# GC0111

## RfG Clarifications to Fast Fault Current Injection

Antony Johnson  
*National Grid – Network Capability*  
*September 2018*

## FFCI Figure ECC.16.3.16(a)

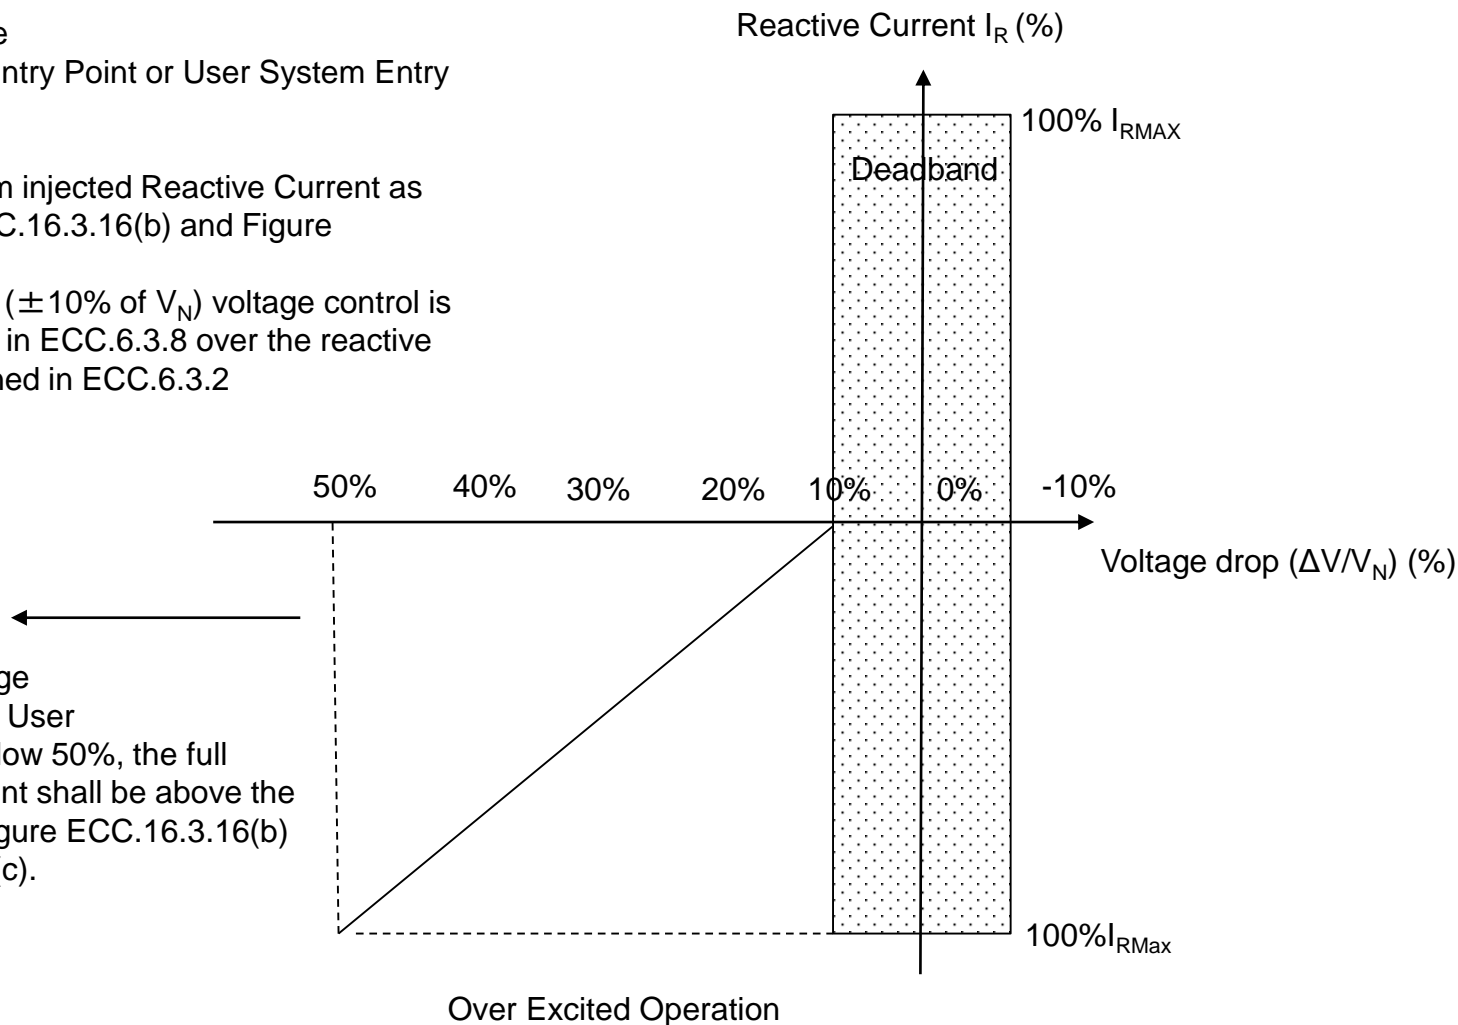
- 
- A new voltage / Reactive Current requirement has now been introduced similar to that adopted in a number of other European countries
    - Defines the Fast Fault capability required for a specified voltage drop.
    - For voltage drops below 50% of nominal full reactive current injection is required
    - Amendments to ECC.6.3.15.9 (ie fault ride through - voltage dips in excess of 140 ms) to ensure consistency with fast fault current injection requirements.
  - The requirements for fast fault current applies to both balanced and unbalanced faults. Reference is now made to RMS positive phase sequence RMS values.
  - A new clause (ECC.6.3.16.1.4) has been added with regard to the transition from pre-fault operation to post operation. This is to address the pre-fault operating conditions of the Power Park Module or HVDC Equipment

- The criteria for fast fault current injection is closely linked to the requirements for fault ride through
- Criteria defined with respect to a voltage / reactive current characteristic (Figure ECC.16.3.16(a) – Slide 5)

# FFCI Figure ECC.16.3.16(c)

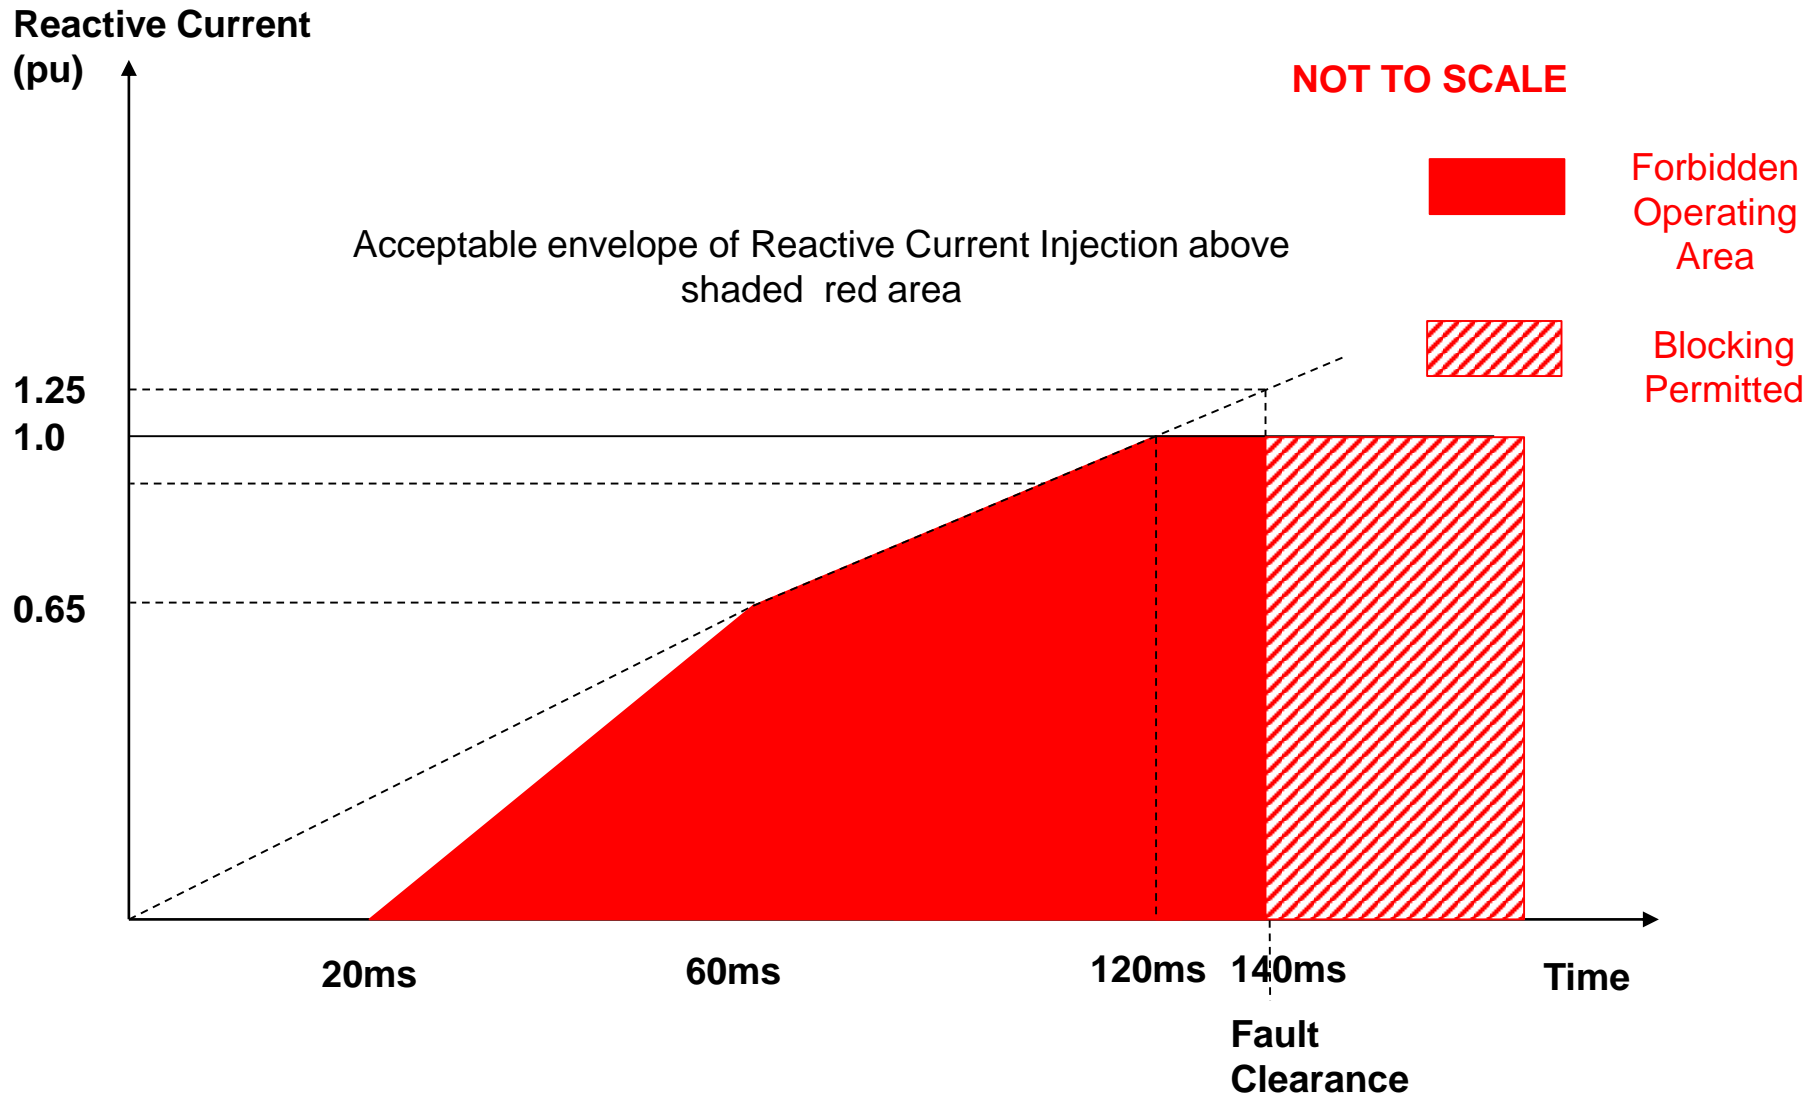
- Full reactive current injection is required as per Figures ECC.16.3.16(b) and ECC.16.3.16(c) (Slides 6 and 7)
- Under fault conditions the Power Park Module or HVDC Equipment would not be expected to exceed the locus shown in Figure ECC.16.3.16(d) (Slide 8)
